STATE OF NEW MEXICO  
OIL CONSERVATION COMMISSION

CASE NO. 13480

**COMMENTS BY THE NEW MEXICO CITIZENS FOR CLEAN AIR & WATER, INC.,  
REGARDING PERMIT CONDITIONS PROPOSED BY NMOCD.**

**Fig. 1. Diagram of moisture detection scheme.**  
(not to scale)

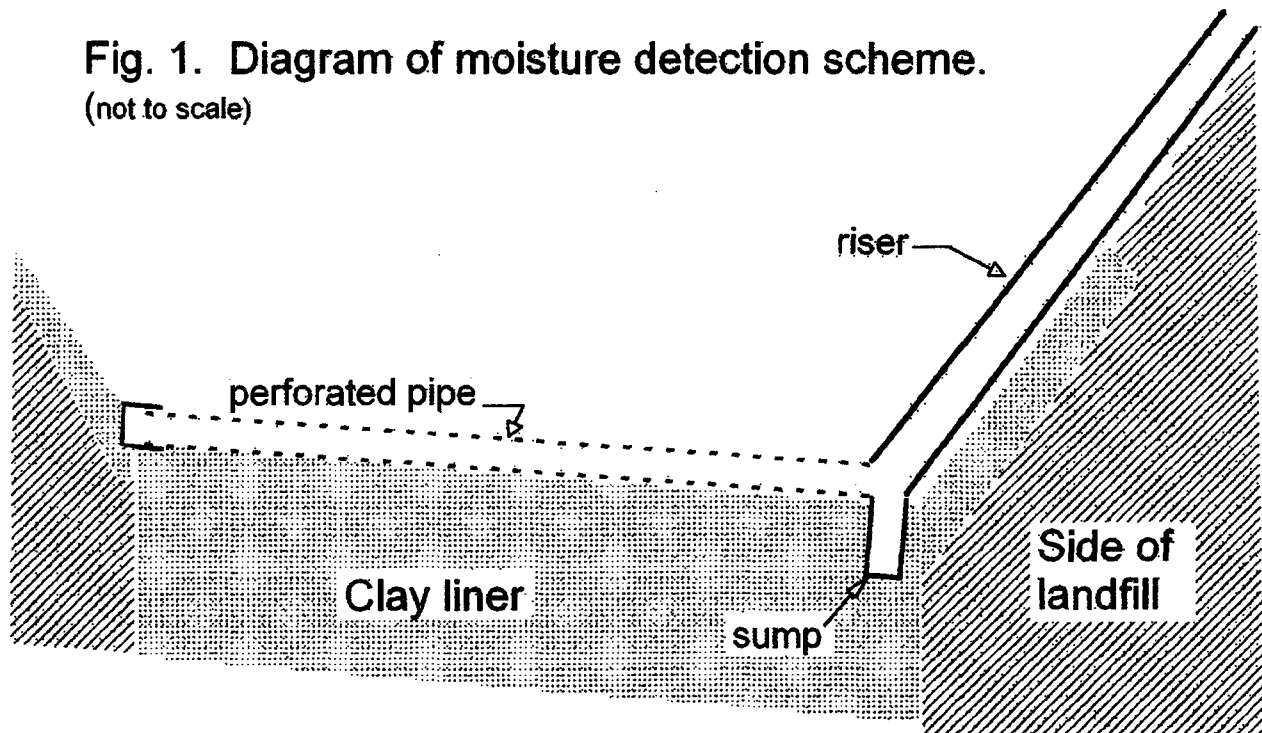
We suggest the proposed monitoring with boreholes would be ineffective. A depth of water would exist in a borehole only if the ground were saturated at some level by a confining layer, and if the borehole itself did not serve as a conduit to disperse the water at a lower level. The most likely situation is that water will pond in the bottom of the landfill, seep out at a preferential location, and move downward via a preferential pathway, never saturating the location of either borehole.

Figure 1 is a diagram of a monitoring scheme that we believe would be lower in cost and more effective than the boreholes. At intervals of approximately 50 ft, a perforated pipe lies on the bottom of the landfill, or better, at the top of the clay liner. This monitoring system will be more effective if the upper surface of the liner has a slight slope, as shown. The upper end of the nearly horizontal perforated PVC pipe is capped. The lower end terminates in a small sump and a riser that extends a few feet above the cap of the closed landfill. Water gathering at the bottom of the landfill would easily be detected by a probe or by a resistance detector lowered to the sump. If the landfill is 20 ft deep or less, water might be extracted with a suction pump on a tube lowered into the riser. For the proposed depth of landfill, a submersible pump might be needed.

Perforated pipe may be laid within the operations layer or on the clay liner.  
Perforated pipe may be laid on a plastic sheet or fiberglass mat to prevent movement of clay into perforations, and may be covered with fiberglass mat to prevent movement of soil from the operations layer into perforations. The layer of operations soil is not shown.
